TXX-2912

COMANCHE PEAK STEAM ELECTRIC STATION
TRANSMITTAL OF MATERIAL REQUESTED
BY QUESTION 032.1
FILE NO. 10010

032.0 INSTRUMENTATION AND CONTROL SYSTEMS BRANCH

Q032.1 Provide a listing of the sections of the FSAR which include the responses to the staff positions and questions transmitted to all applicants with RESAR-3 plants. This transmittal was dated November 17, 1977.

FIGURE Q032.1-7

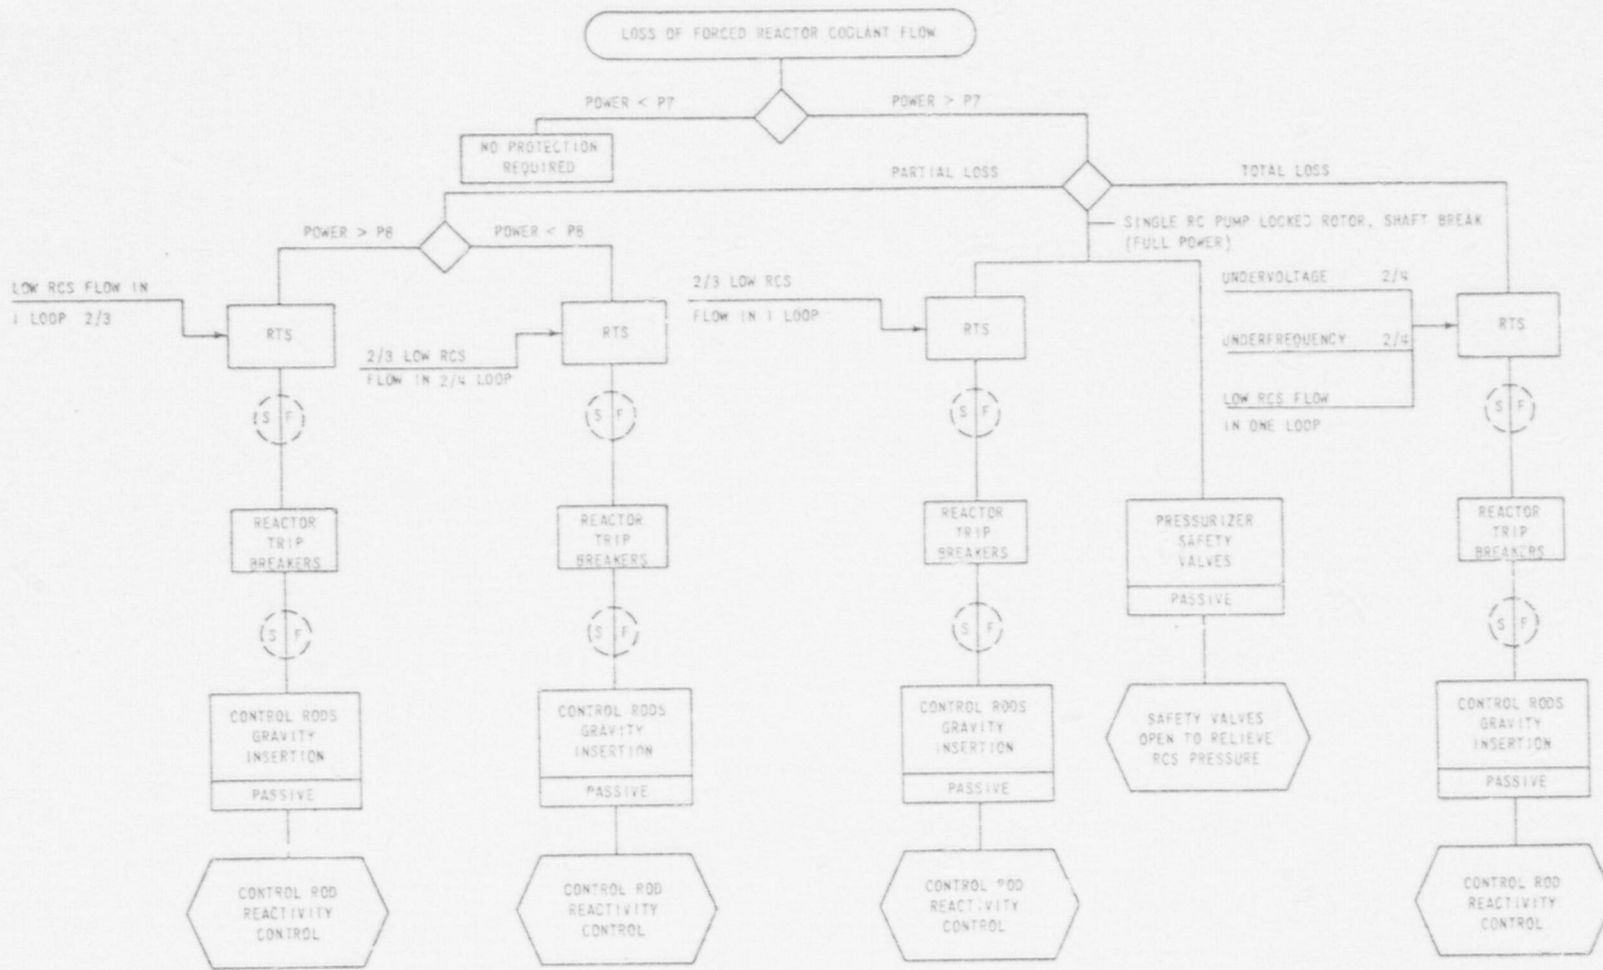
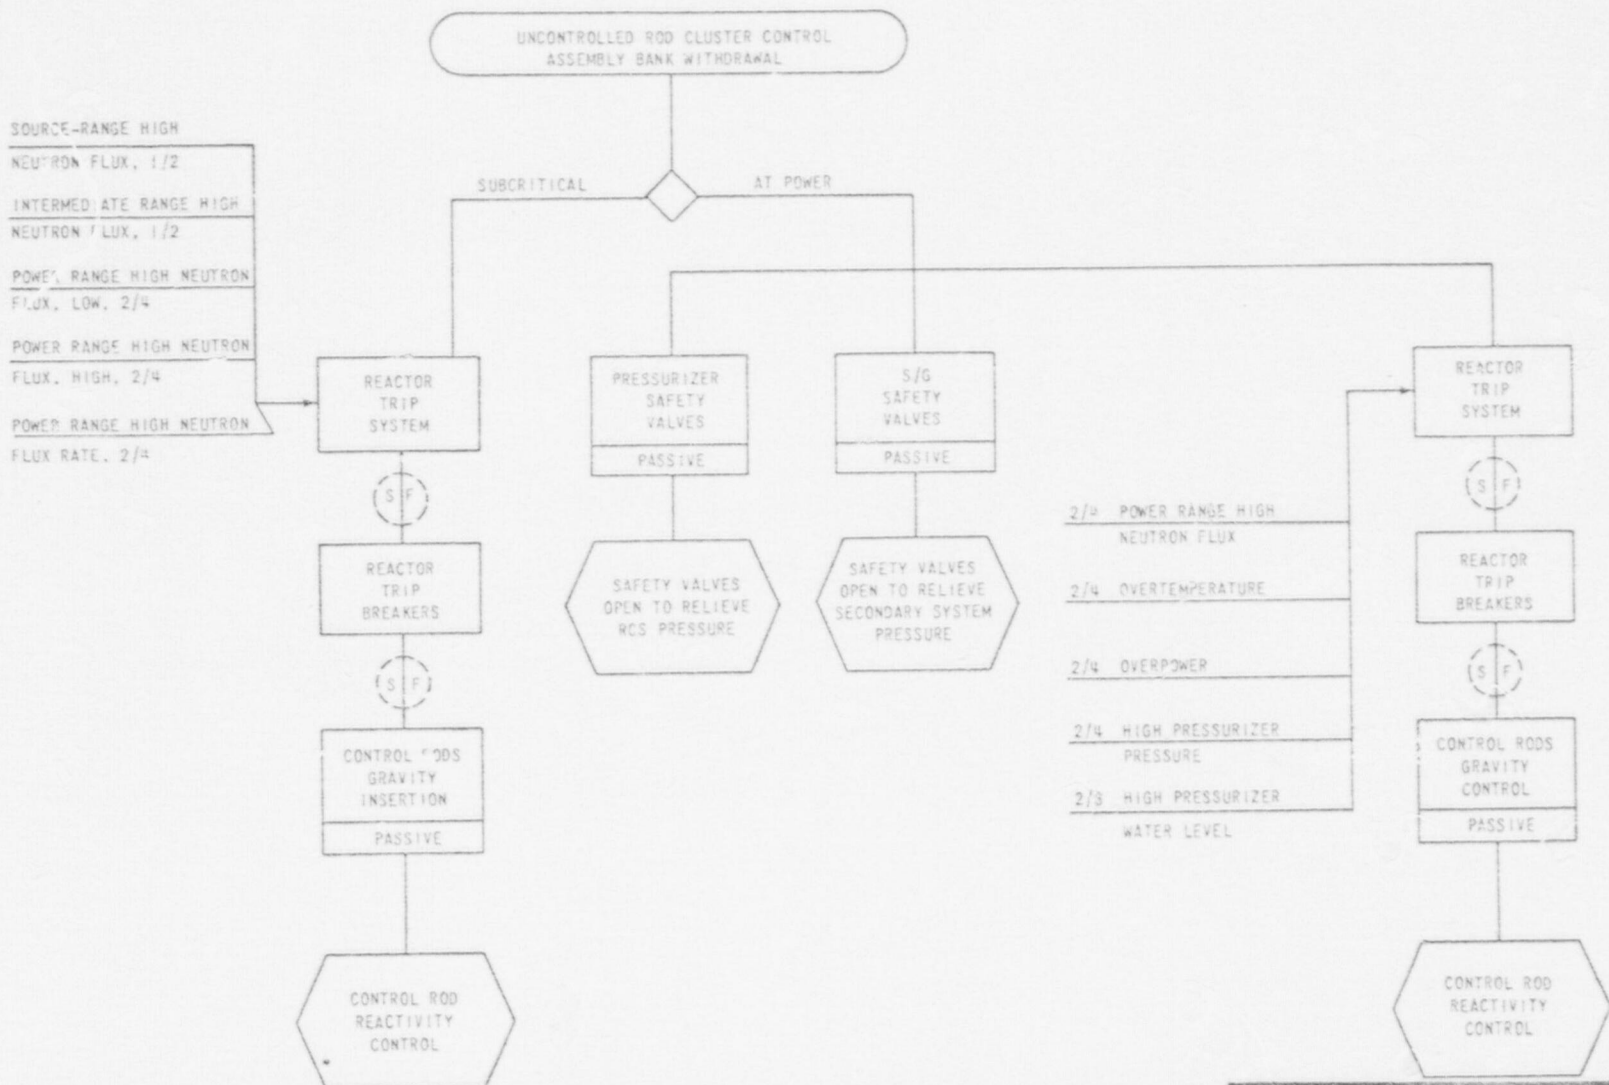
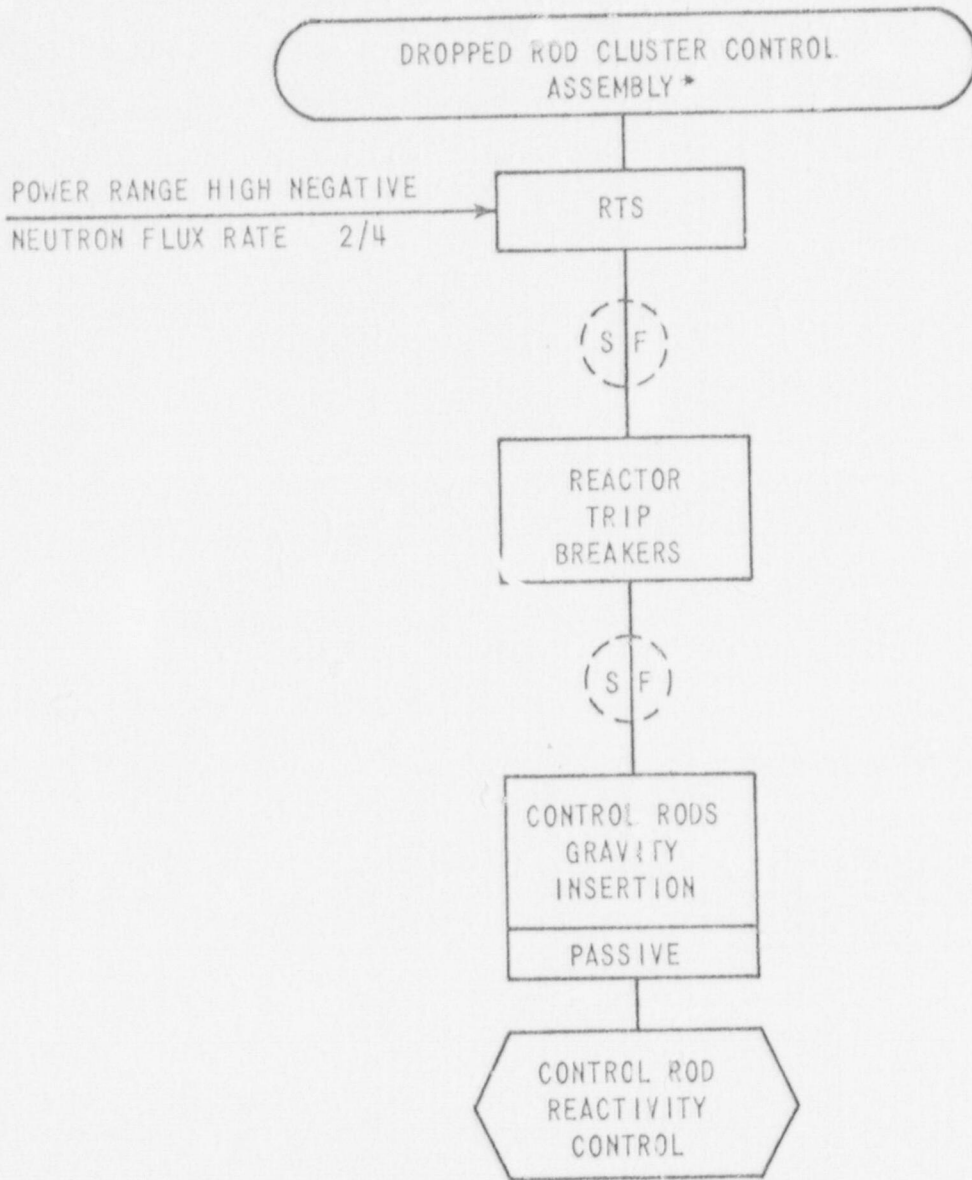
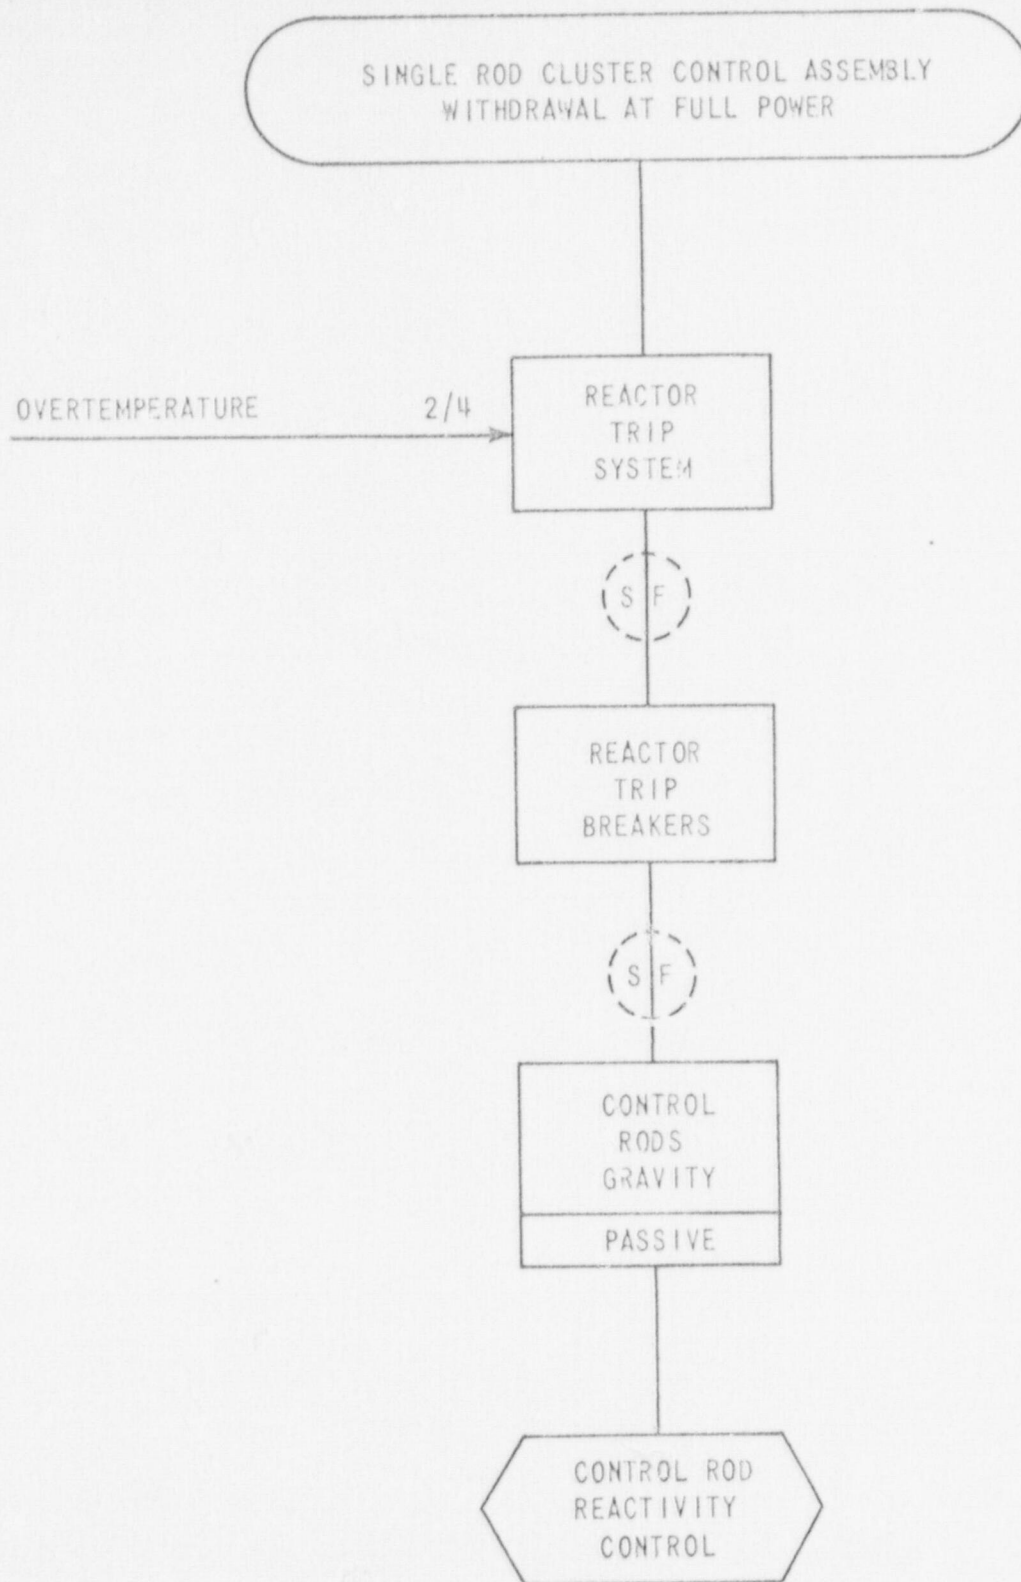
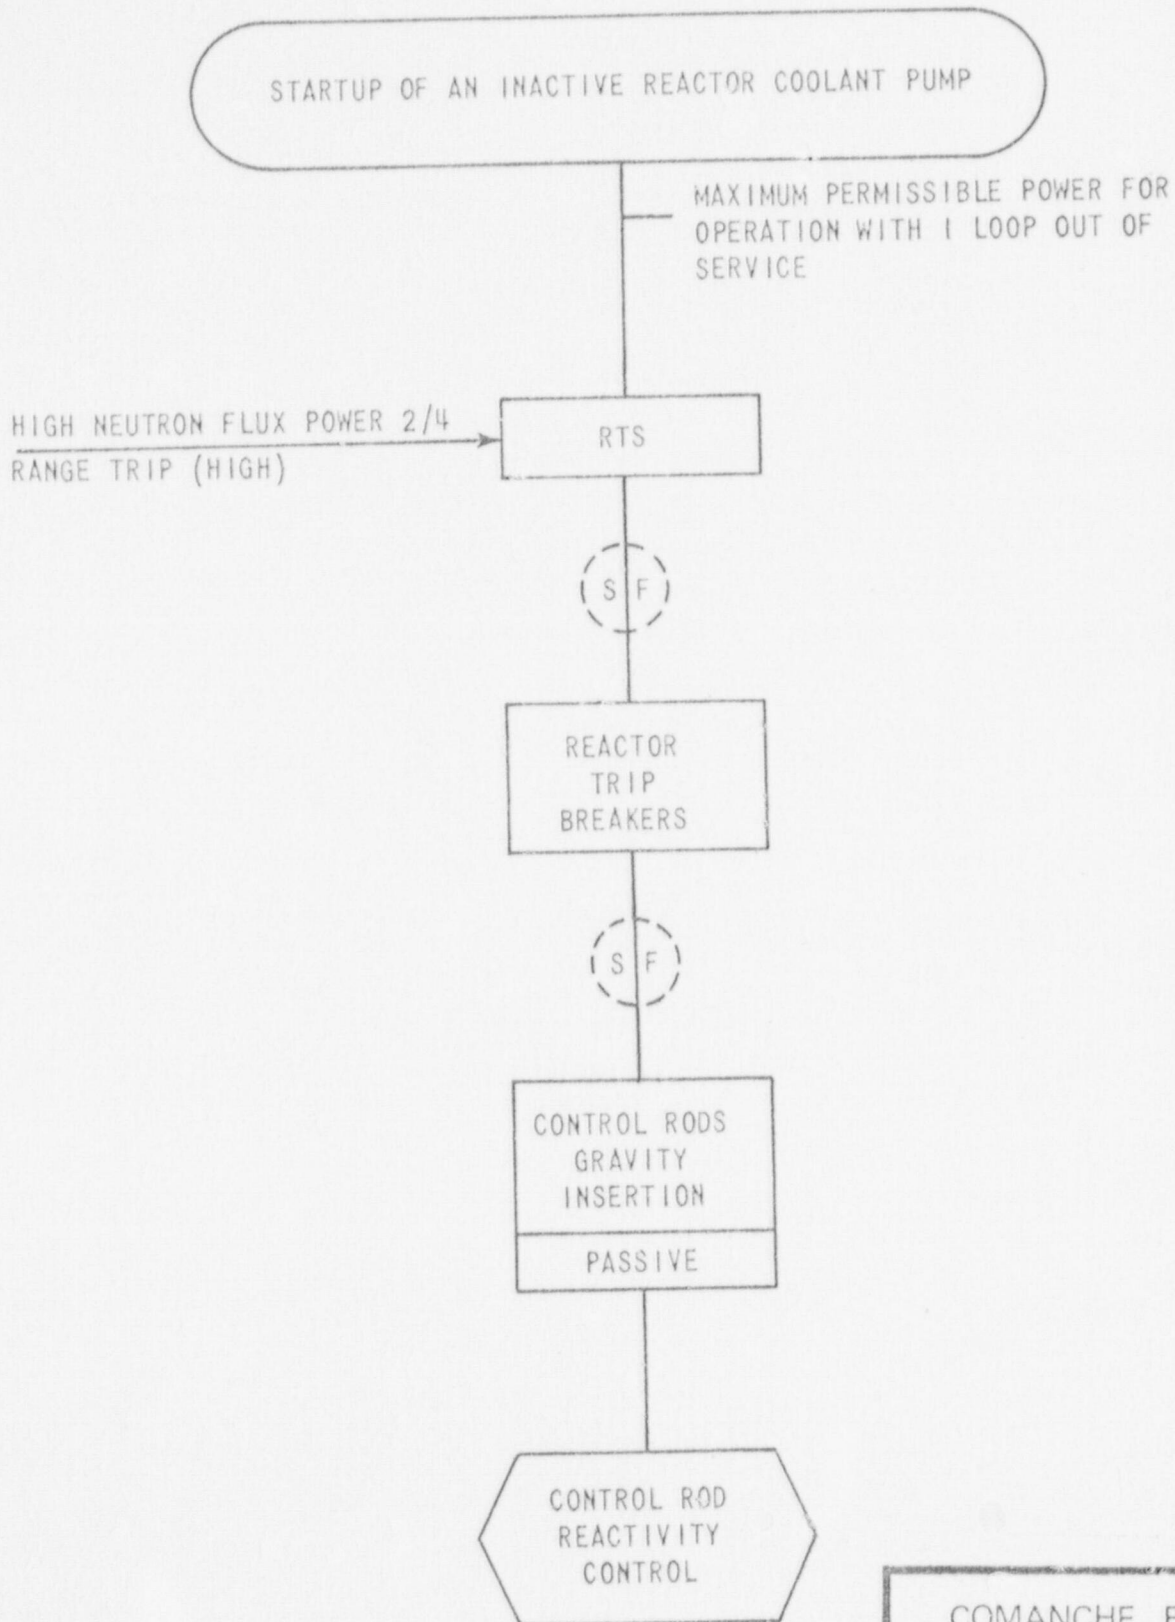
RESAR-3 For each transient and accident analyzed in Chapter 15,
(15.0.1) provide the following information:

- (1) The step-by-step sequence of events from event initiation to the final stabilized condition. This listing should identify each significant occurrence on a time scale, including for example: flux monitor trip, insertion of control rods begin, primary coolant pressure reaches safety valve set point, safety valves open, safety valves close, containment isolation signal initiated, containment isolated, etc. All required operator actions should also be identified.
- (2) The extent to which normally operating plant instrumentation and controls are assumed to function.
- (3) The extent to which plant and reactor protection

systems are required to function.

- (4) The credit taken for the functioning of normally operating plant systems.
- (5) The operation of engineered safety systems that is required.

Response These diagrams are given in Figures Q032.1-1 to Q032.1-24.
